## FINAL ORDER

The Special Standards Request Form you submitted for landowner: Train Mountain Institute, Jerald Crane, Start Card number: 1073690, is hereby approved for the following: You may decommission this water supply well (KLAM 1219) as described on your Special Standards Request Form dated May 9, 2024. All other well abandonment standards apply as required under Oregon Administrative Rules 690-220. A copy of your Special Standards Request Form is enclosed.

## Special Standards Request Form

**Well Inside of  
this small area**

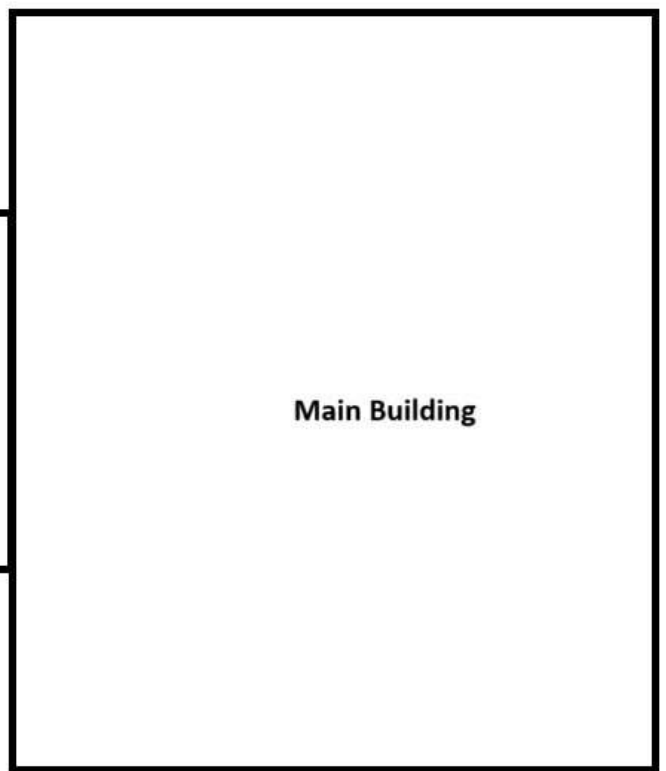
The unusual conditions which necessitate this request: Lack of drilling machine access to the well location

The proposed construction methods that the well constructor believes will be adequate for this well: The old well is inside of an insulated side area of a building that they don't want to move or remove. (see attached picture). We propose simply backfilling the 6" casing from the bottom up with 3/8 Sodium Bentonite up to ground level.

Approval of this Special Standards Request was granted on May 10, 2024, due to the photo you provided showing the lack of access for a drilling machine to the well location.
